MODEL XJ Range

NUMBER \$724 ISSUE: 2

TECHNICAL BULLETIN

SERVICE ACTION S724: Constant Battery Drain

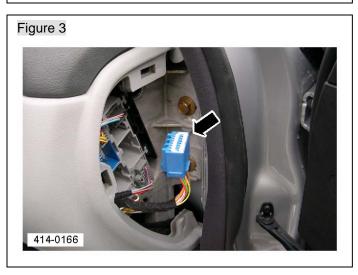
1. Pull away the right-hand side door/dash area rubber dust seal. (Figure 1)
